**SB Style Composite Ltd.  
ZS Apparels  
ZS Embroidery  
Jabber Fashions Ltd.  
Patriot Printing Industry  
Patriot Packaging Industry**

Delpara, Fatullah, Narayanganj  
(23.67101N 90.48441E)  
30<sup>th</sup> April 2014

# Observations

4 Building has no obvious lateral stability

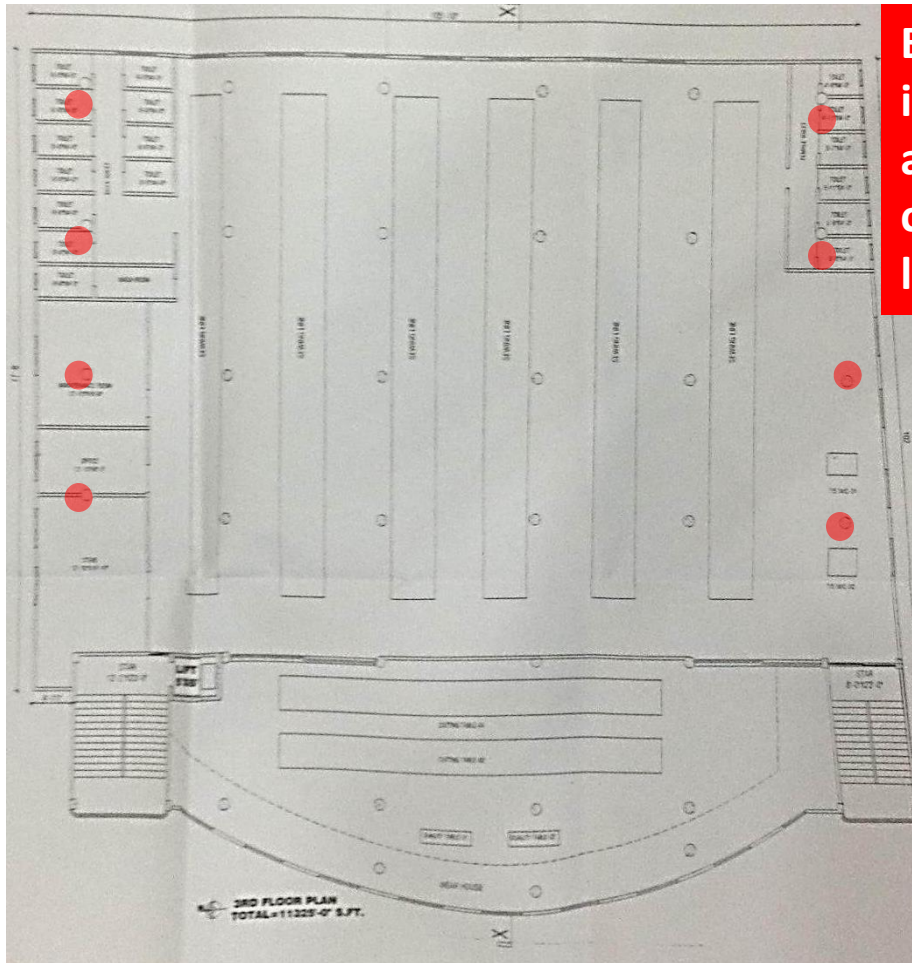
Building has no obvious lateral stability as flat slabs between 170 and 190mm are questionable in terms of adequate frame action. Perimeter Façade walls are half a brick thick (order of 130mm thick including render) and are not continuous to ground in many cases

DETAILS OF FLAT SLAB DESIGN

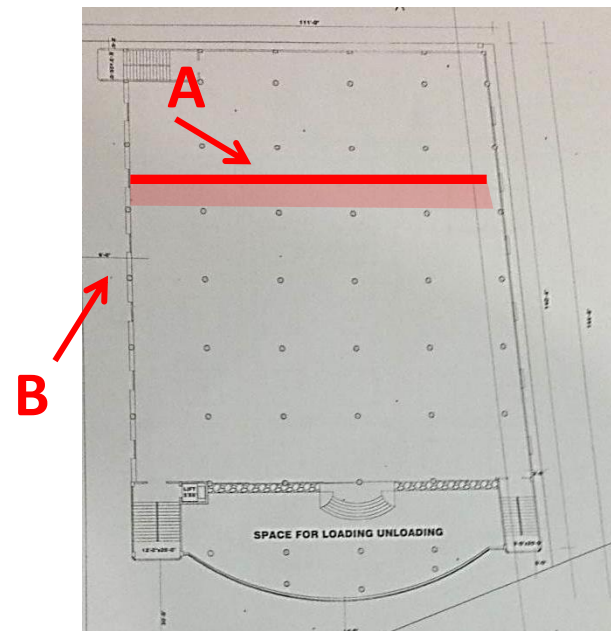
**Edge columns have only 12 vertical bars compared to the 14 shown on the drawing.**

Rear of building appears to be non-engineered

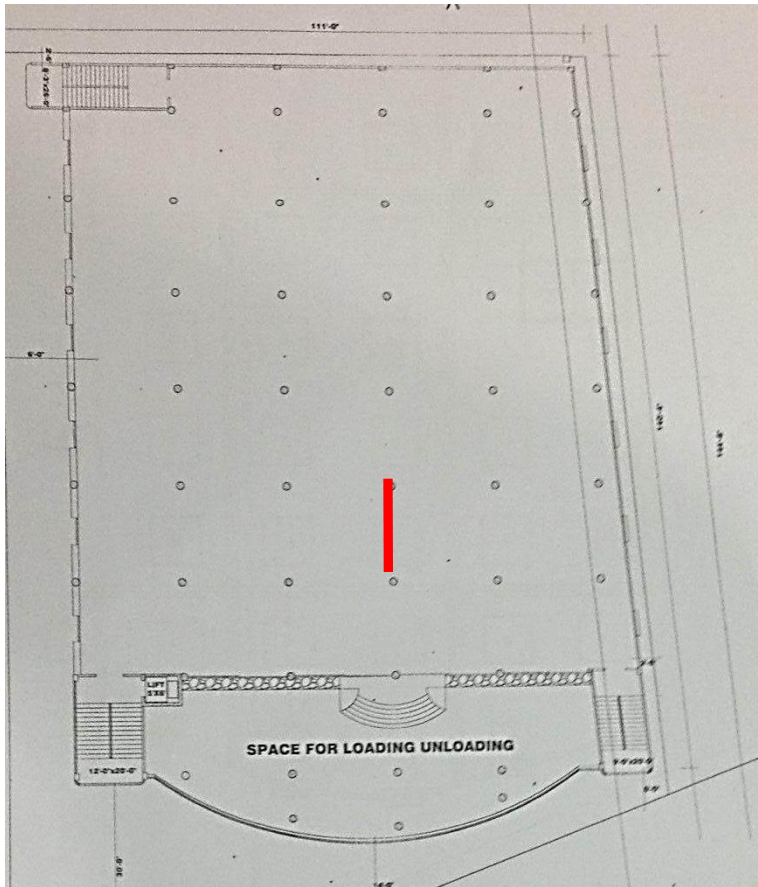
The rear of the building has very long span slabs and a missing downstand beam (there is some evidence of a previous wall on the missing beam line).

- High floor leads to be removed by completely emptying floor as noted on drawing under Item 1.
- Adequacy of slabs and beams to be confirmed as part of Item 1 Detailed Engineering Assessment.

## Toilet demolition - Option 1

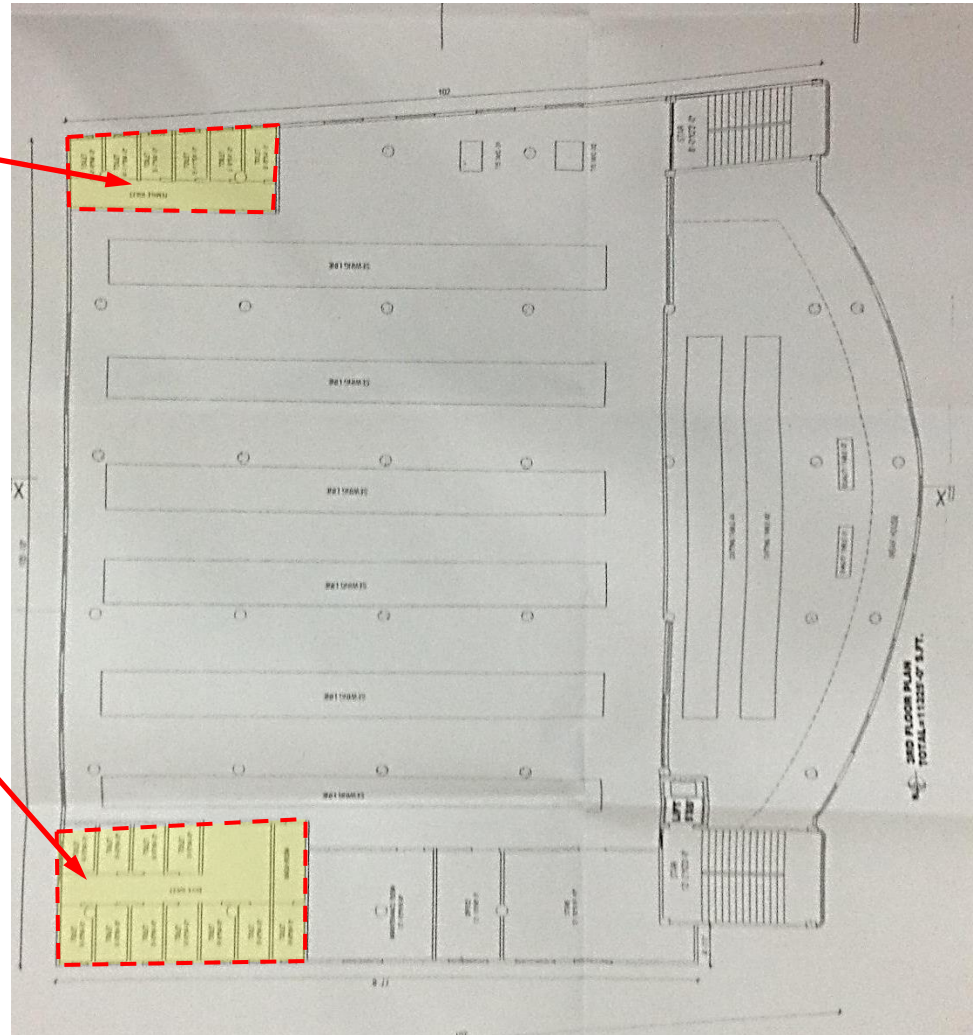
Maximum of 1 toilet cubicle allowed in this area at any floor.

Maximum of 1 toilet cubicle allowed in this area at any floor.

All other cubicles and floor finishes in these areas to be demolished and removed from building.

- Option 1 - Reduce number of toilet cubicles to one male and one female by demolishing all partition wall and removing all floor finishes above slab level as shown overleaf .Demolition works to be carried out with care to avoid impact loads on slab. Option 2 - Alternatively restrict access in toilet areas and install temporary lightweight toilet facilities on each floor as shown overleaf until DEA is complete.
- Qualified Structural Engineer to carry out a Detailed Engineering Assessment of Factory, see attached scope.
- In addition verify insitu concrete strength either by taking 4 no. 100mm diameter cores. Structural Engineer to determine safe locations for coring in centre of bay.

## Toilet relocation - Option 2

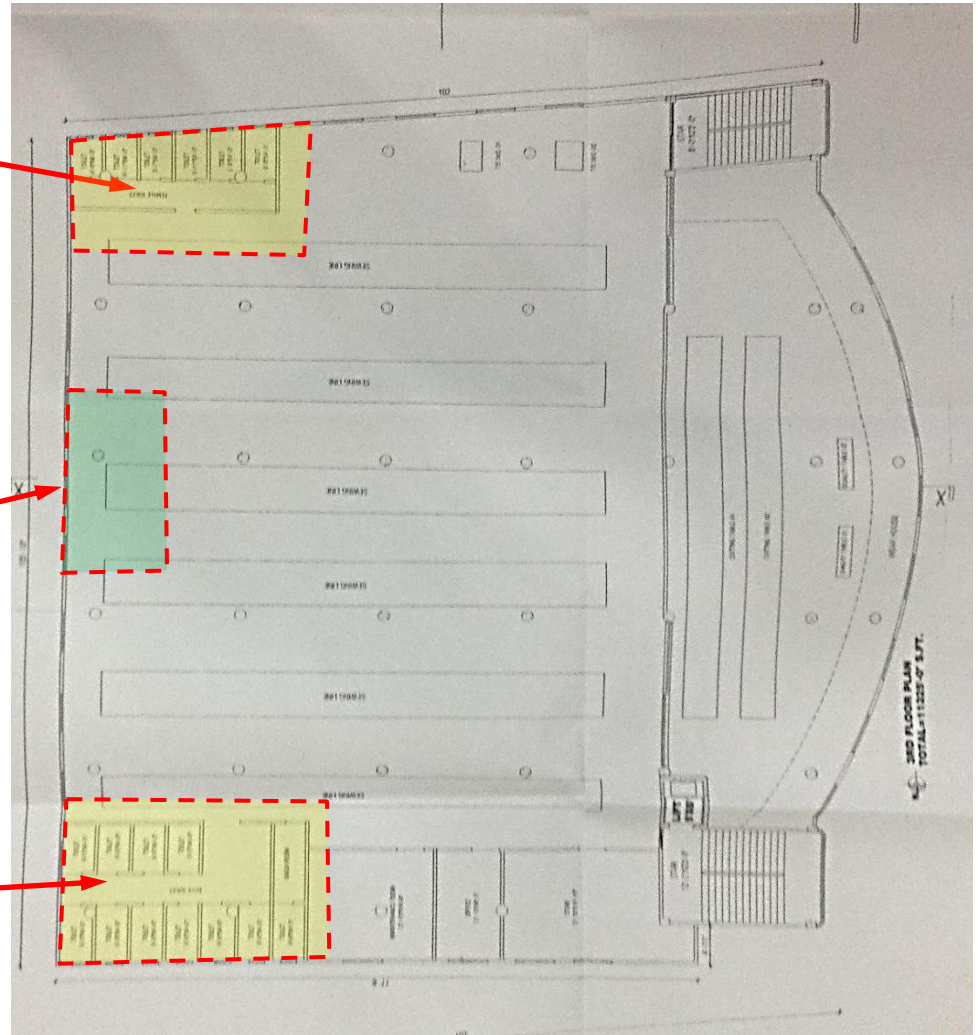
Isolate all access and personnel in this area, no access to Toilets

Provide lightweight temporary toilet facilities in area supported by large diameter column with column head

Isolate all access and personnel in this area, no access to Toilets
